# Appendix AA

## Public Comment Letters and Responses

### RE: Kern County Subbasin May 2024 Draft Groundwater Sustainability Plan - Subsidence

**RE: Response to Western State Petroleum Association (WSPA) Comments Dated August 29, 2024, on the May 2024 Draft Groundwater Sustainability Plan (GSP), Kern County Subbasin, Related to Land Subsidence.**

Figure 8-71. Time Series for AOI-5 Track H-H'

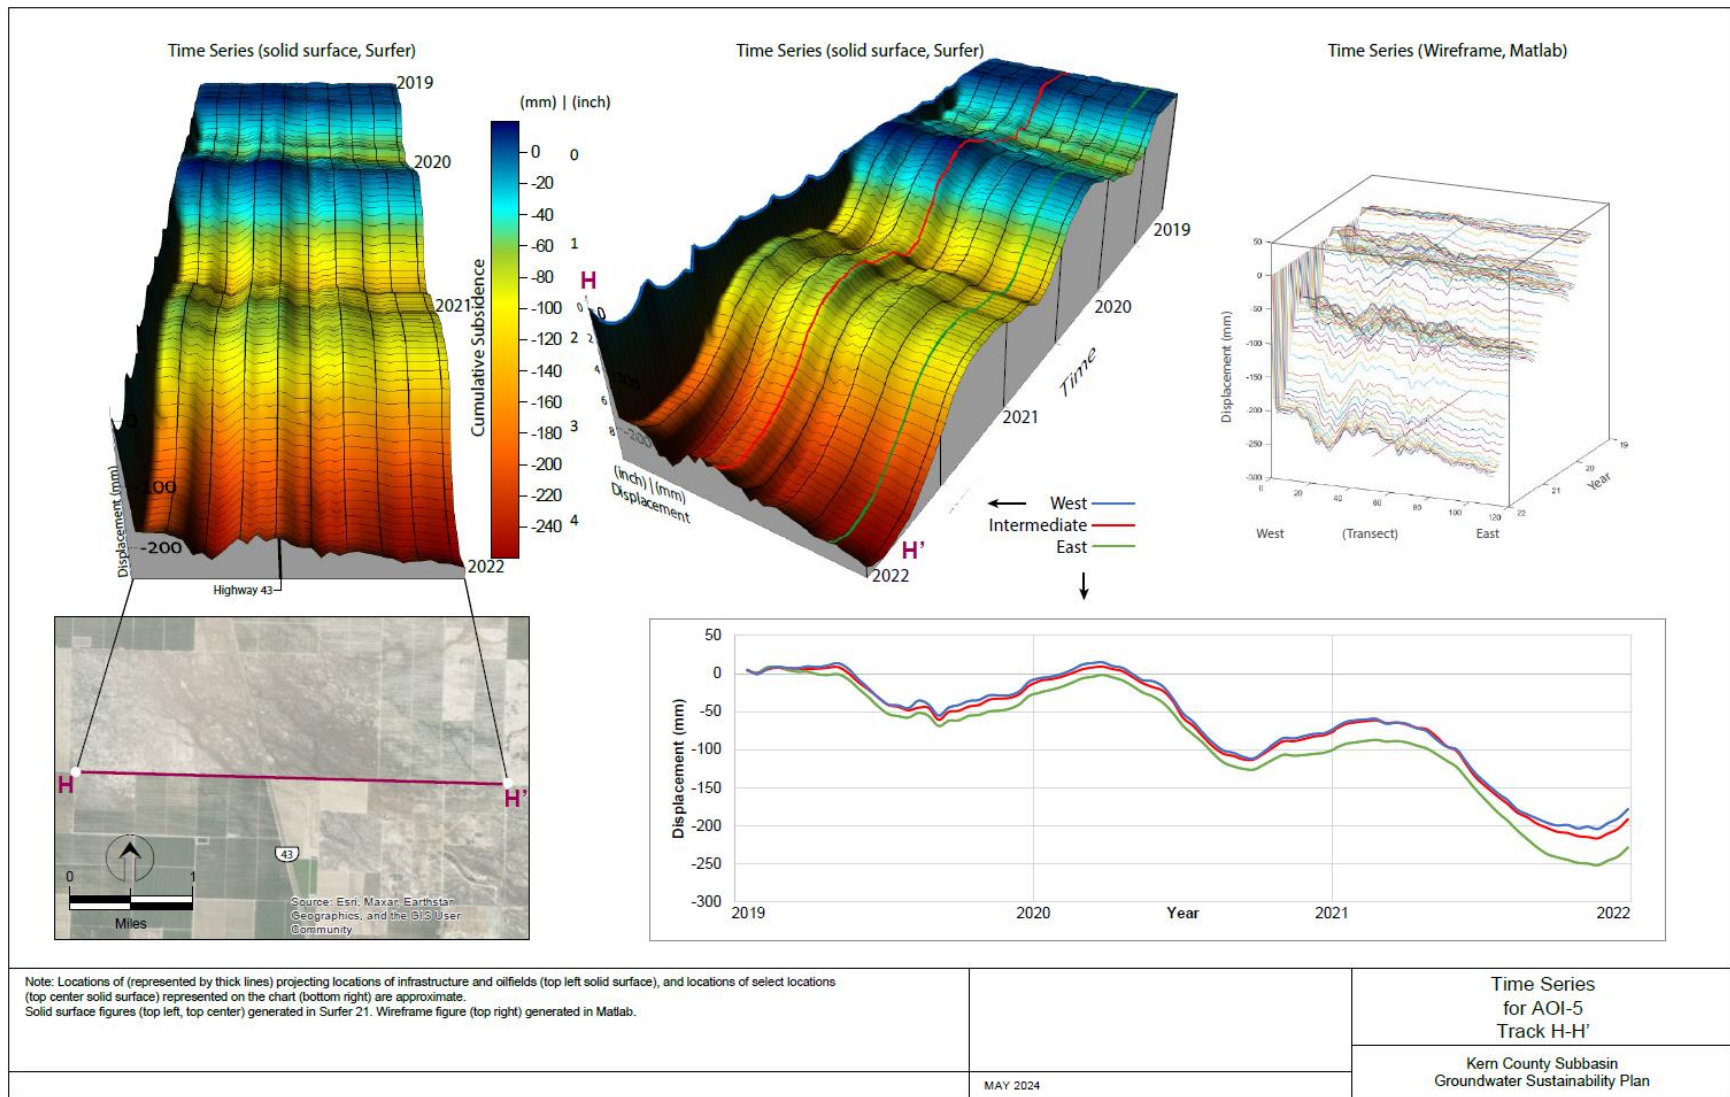
**WSPA Comment #12 – Summary:** The May 2024 Draft GSP fails to explain how the GSAs can differentiate between GSA-related and non-GSA related subsidence when both occur in the same area.

**Response to Comment #12:** As stated in Section 8 of the Draft 2024 GSP Report, using InSAR time series it is possible to differentiate between different types of extraction activities. Agricultural pumping (e.g., GSA-related pumping) has a seasonal pattern that is discernible in InSAR time series data as a sine wave-like pattern over a period of extended time. By contrast, non-seasonal pumping, for example, oilfield activities near the Aqueduct (e.g., MP 195 to 215) and elsewhere, tend to have a “busy” or “noisy” less sinuous pattern and a steeper declining slope reflecting non-seasonal (i.e., full time) activities.

In the Subbasin 2024 Draft GSA Report, **Figure 8-71** provides an example of the InSAR time series signature for agricultural pumping (i.e., GSA-related). In this time series all the time series lines are in harmony and have a sine-wave shape indicative of seasonal pumping activities. Non-seasonal pumping, for example oilfield activities near Aqueduct MP 204, tend to exhibit a less sinuous pattern (i.e., noisy pattern) and a steeper declining slope reflecting non-seasonal (i.e., more sporadic) pumping. **Figure 8-66** in the 2024 GSP provides an example of a non-GSA time series signal (see also, **(Appendix E)** in this response letter). More detail is provided in Section 8.5 of the Subbasin 2024 Draft GSP Report. Based on the WSPA comment, the Subbasin will review **Section 8** of the Subbasin Draft 2024 GSP to ascertain if we can expand or further clarify the existing text in the Final 2024 GSP.
